**Airways New Zealand submission to the  
Civil Aviation Authority's  
2016 Waikato and Bay of Plenty Airspace Review**

**Updated Submission**

**20 November 2015**

**Hamilton CTR and CTA Proposal**

# Airways DRAFT Proposal dated 22 October 2015

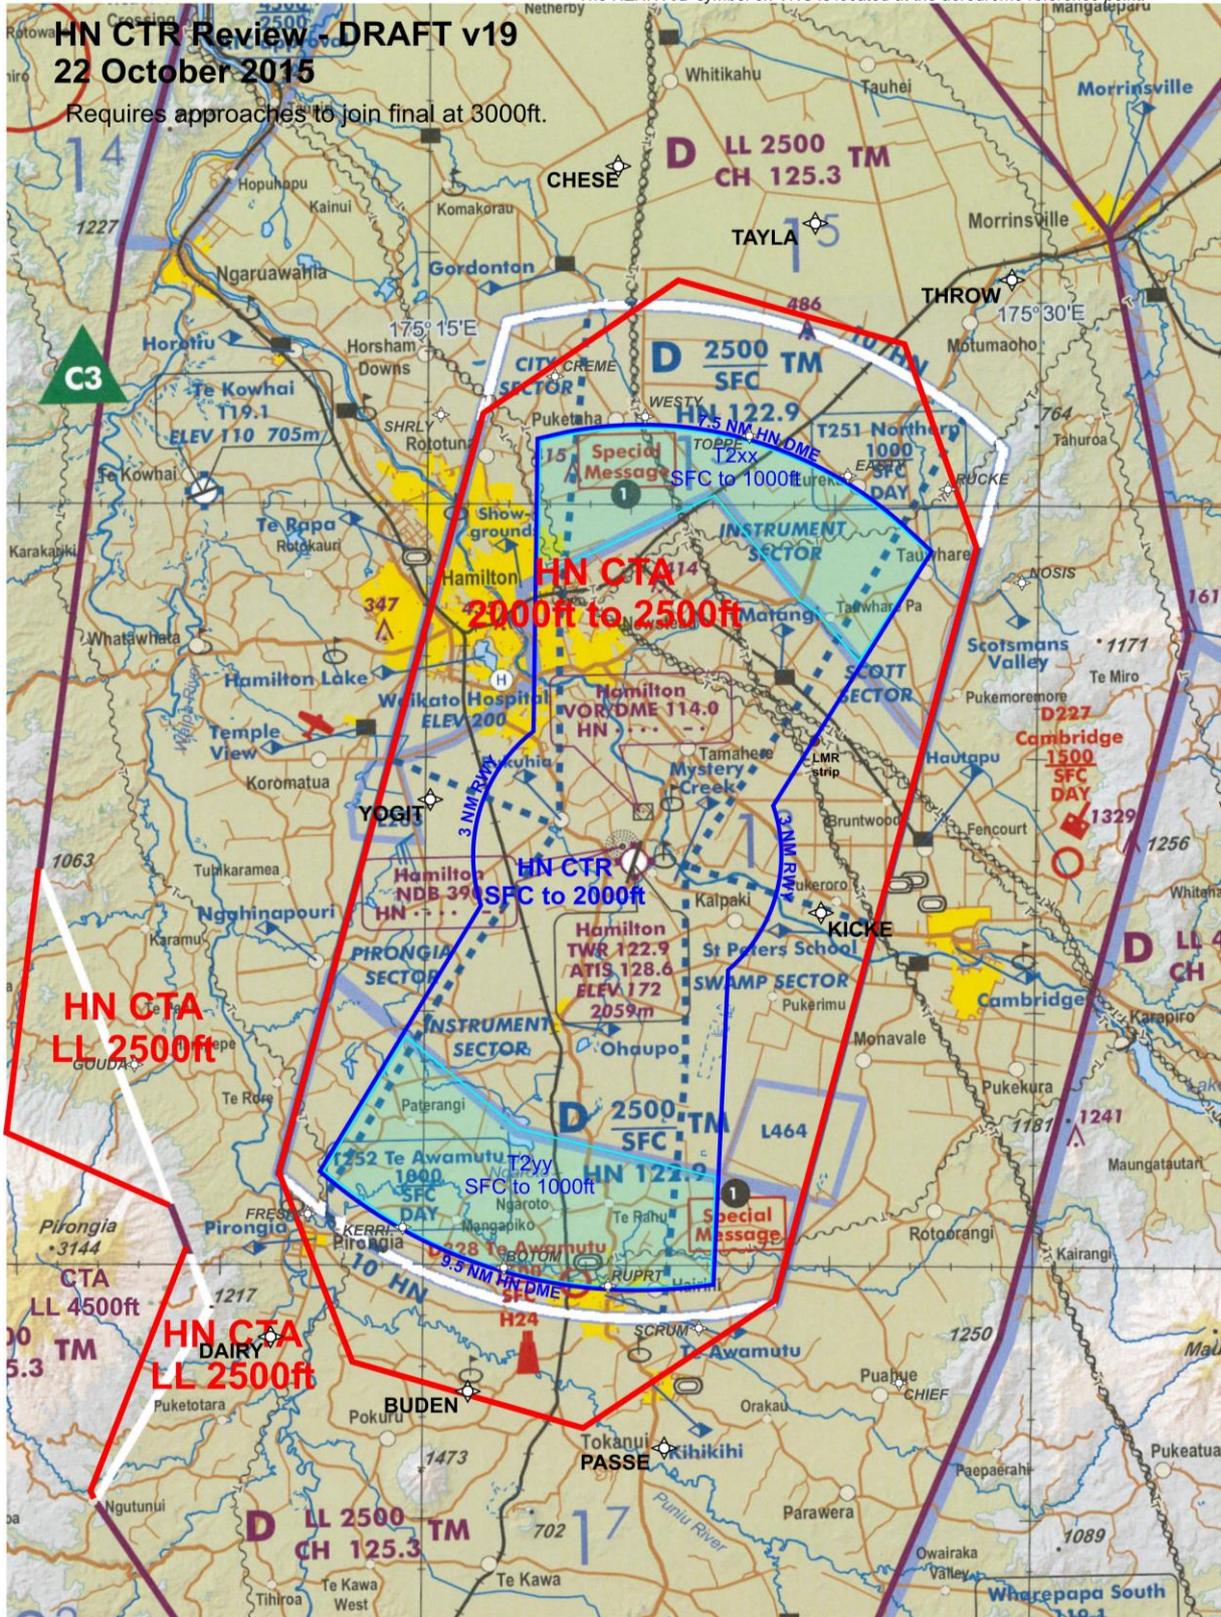
Below is the Airways proposed new HN CTR, associated new HN CTA LL 2000ft and amended HN CTA LL 2500ft as at 22 October 2015.

Probable new IFP waypoints also depicted  
15 degree SIDs split from RWY THR

Note: 3 NM circle - centred on NZHN ARP. Fans widened to the East.  
The NZHN A/D symbol on VNC is located at the aerodrome reference point.

1. The design reduces the size and upper level of the HN CTR as much as practical to contain the instrument approaches and departures and provide suitable containment of circuit operations at HN.

2. The upper level of the DRAFT CTR is 2,000ft AMSL, lower than the existing 2,500ft.
3. The lowered CTR upper level requires the addition of a new HN CTA airspace extending from 2,000ft to 2,500ft to reach the lower level of NZA245. In general, the lateral dimensions of this new CTA are the same as the existing HN CTR but note the extensions to the south and north.
4. The existing HN CTA LL 2500ft (NZA245) would be changed in the Pirongia area to contain proposed new PBN instrument flight procedures.
5. Airspace containment criteria applied

6. The central 3 NM circular portion of the CTR is centred on the RWY 36R/18L centreline at a point abeam TXY A. Note that the NZHN aerodrome symbol depicted on VNC and the DRAFT is located at the NZHN aerodrome reference point which is to the east of RWY 36R/18L.
7. The 3 NM circular portion provides containment for instrument approach Cat A and B circling approaches. Cat C and D circling is not contained.
8. L263 lies outside the CTR by not less than 1 NM.

9. The width of the CTR fans is not less than the existing Instrument Sector and therefore provides containment for the inbound legs of the existing and proposed amended IFR approaches.
10. The width of the CTR fans is primarily determined by the 2 NM buffers for the planned new PBN departure procedures. These new departure procedures will consist of a straight ahead departure, a departure that turns 15 degrees left of RWY centreline and a departure that turns 15 degrees right of centreline.
11. L464 lies just outside the CTR.

12. Unfortunately, the Lee Martin Road Airfield (LMR strip) does not lie outside the DRAFT CTR.

Based on the photo of the LMR strip on the Aerosport website, Airways believe that the DRAFT CTR boundary would pass over the centre of the strip (orientated 10-28) – i.e. the western half of the strip would be inside the CTR, whereas the eastern half would be outside.

Some possible solutions that could be put to CAA for their consideration are;

1. A reduction in the airspace containment criteria in that area which would allow a small indentation in the CTR boundary around the LMR strip; or
2. The addition of a small transit lane (about 0.5 NM diameter?) around the strip with an upper level 700ft AMSL.
